**BEFORE INDEPENDENT HEARING COMMISSIONERS
AT PORIRUA**

**HEARING STREAM: Hearing Stream 7 – Variation 1; Plan Change 19;
Residential; and Commercial Zones**

**STATEMENT OF PRIMARY EVIDENCE OF MARTIN GLEDHILL
ON BEHALF OF KĀINGA ORA – HOMES AND COMMUNITIES**

(ELECTROMAGNETIC FIELD SAFETY)

Figure 1. Calculated electric and magnetic field strengths as a function of distance from the RNZ Titahi Bay transmitter, based on a mast height of 137 m and the licensed transmitter powers and frequencies.

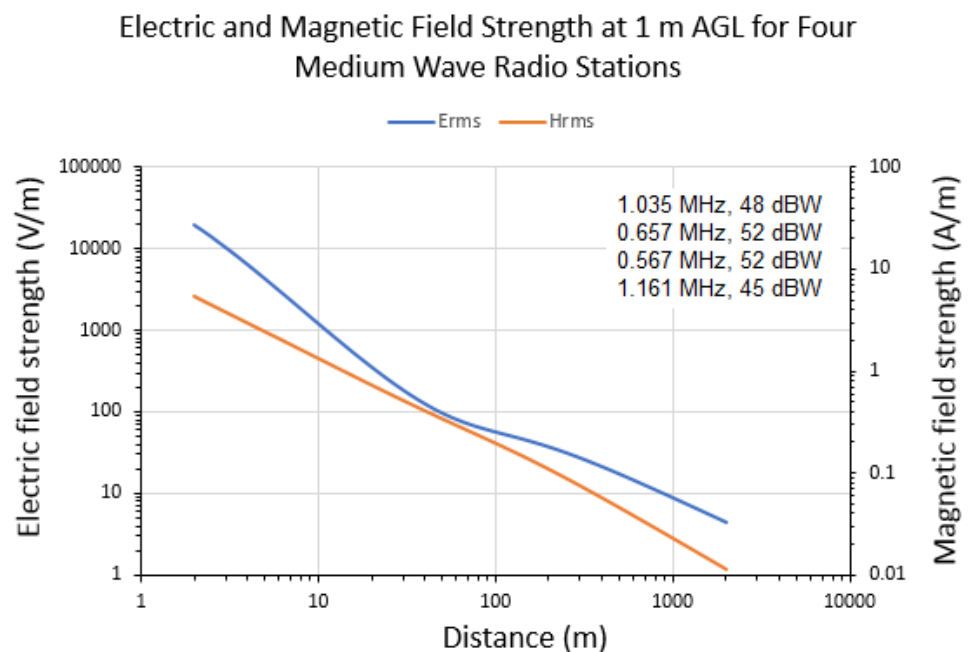
- 3.13 It is also not clear why a difference of one metre in building height, between 10 m and 11 m, should be so critical in determining whether exposures are likely to comply with the limits or not, all the way from 200 m from the site (distance of the closest house) to 1057 m from the site. One of the key factors in determining compliance is the strengths of the electric and magnetic fields. Figure 1 shows the electric and magnetic field strengths 1 m above ground level as calculated by Mr Tell (based on the mast height of 137 m and the licensed transmitter powers taken from the Radio Spectrum Management licensing database). These suggest that the electric field strength decreases by a factor of about 4.5 between 200 m and 1000 m, and the magnetic field strength by a factor of about 6.7.

3.19 In summary, in my opinion the technical material provided by RNZ is insufficient to justify the proposed height and distance rules for the inner and outer zones. Rather, the distance to the boundary between the zones, and for the extent of the outer zone, and the height rules proposed, appear somewhat arbitrary.

Figure 2. Electric and magnetic field strengths for the 567 kHz RNZ Titahi Bay transmitter with a power of 52 dBW.

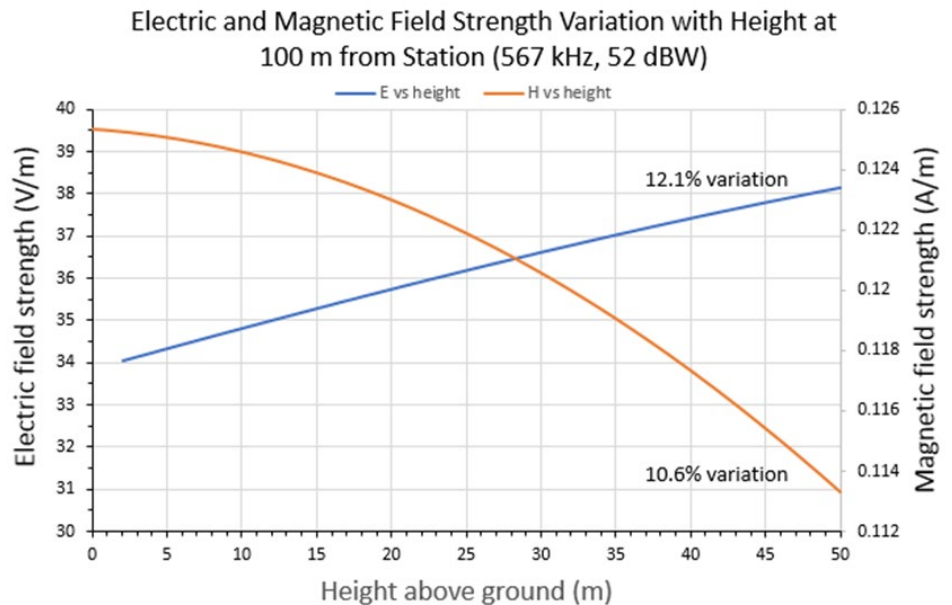
- 3.14 Figure 2 shows Mr Tell's calculations of the variation in field strengths for the 567 kHz transmitter as a function of height, at a distance of 100 m from the mast. These show that there is little difference in the strengths of the fields between 10 m and 11 m above the ground. The

- 3.15 In view of these results, I am unable to understand why it is proposed that the height rules change by only one metre between the inner and outer zones, or assess whether those height limits ensure that exposures do not exceed the limits or are unduly restrictive. This is not explained by RNZ's Attachment 3.
